REVIEW OF HYDROGEOLOGIC REPORTS SUBMITTED BY TEXAS INSTRUMENTS

Enclosed is an evaluation of hydrogeological information submitted by Texas Instruments, Inc. (TI) for their Attleboro, Massachusetts site. We received several hydrogeologic reports and studies from TI in response to a NRC request for additional groundwater information that was made during a special safety inspection on April 24, 1990.

TECHNICAL ASSISTANCE ON TEXAS INSTRUMENTS DECOMMISSIONING PROJECT

ligure 1. Location map of wells on the property.

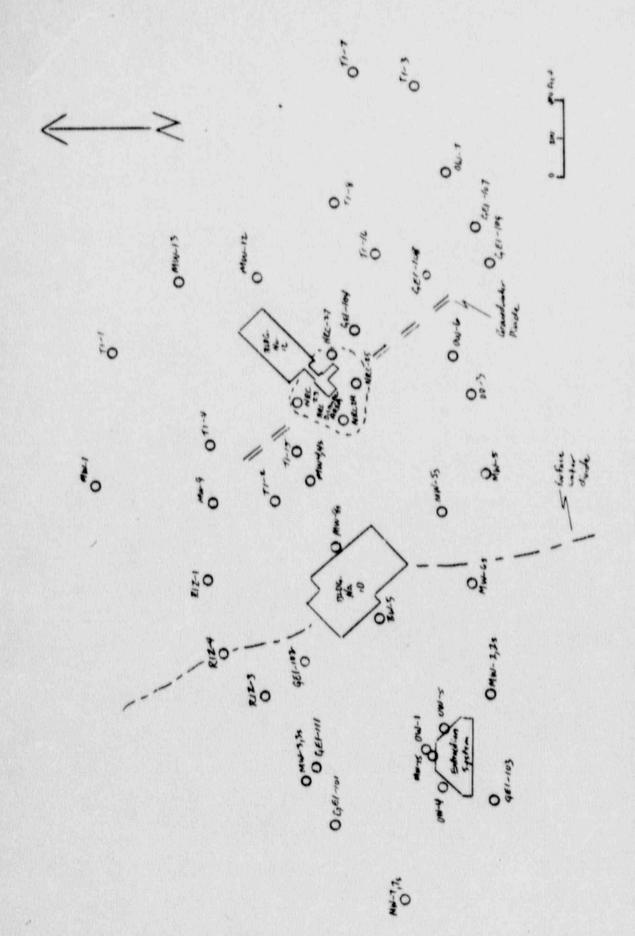
Over the years, Texas Instruments has installed numerous wells throughout the facility (see figure 1) as part of their VOCs characterization effort. Although analyzing samples for radiological contamination from some of these wells will likely be useful, it is unlikely that radionuclides have reached most of these wells. Conservative travel time calculations show that it is unlikely that radionuclides will have traveled farther than 1000 feet down-gradient from the center of the disposal area. of the existing wells, in addition to the NRC wells, the ones located closest to the disposal area appear most suited for taking initial samples. These would include the following wells: MW-4s; TI-4s; TI-15; and GEI-104. In addition, several existing up-gradient wells could be used for determining background concentrations. Wells OW-6 and 7, GEI- 107-109, TI-16, and TI-8 appear most suitable for this purpose. However, prior to using any of the existing wells, Texas Instruments needs to obtain well depth, casing depth, and screen length information to determine which zones are being tested.

Although several of the existing wells could be used to help initially identify the extent of radiological contamination, additional wells are needed, especially closer to the disposal area. These wells should be installed as well nests (i.e., with sampling points at different depths) because of the variability of the overburden material. Slug tests should be ran on several of these wells to obtain hydraulic properties of the materials close to the disposal area; this will facilitate determining the likely contaminant flow paths.

Texas Instruments should sample existing wells near the two areas of concern to initially determine the extent of radiological contamination. Well construction information, such as well depth, casing depth, and screen length should be obtained for any well used for this purpose.

Additional wells should be installed at both locations in order to better characterize the extent of radiological contamination. In addition pump test or slug tests should be performed on several wells to obtain hydraulic properties of the materials in the immediate areas of concern.

Several existing up-gradient wells could be used to determine background concentrations in the overburden and bedrock aquifers. Again, well construction information should be gathered on these wells.
